Access Compliance Report

Public Rights-of-Way

(Curb Ramps)

Intersection ID: 49313	Main Street: ROCKLAND_DR	Cross Street: MISTY_EVE_LN	Location: NE
ADA ID: 4717734B645B	Ramp Type: BlendTrans1	Initial Pass/Fail: Fail	Overall Compliance: No
		Severity Score: 10

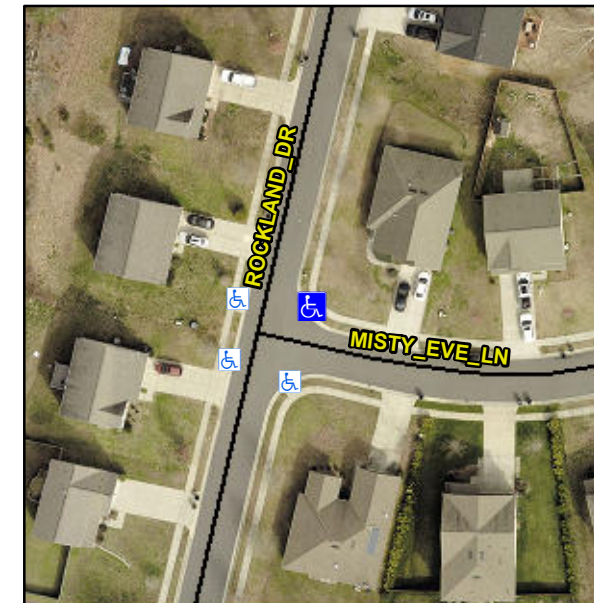
CURB GAP 1.5

Not Found, R304.5.1, R304.5.3

Remove & Replace Curb Ramp With Two New Directional Ramps or Equivalent.
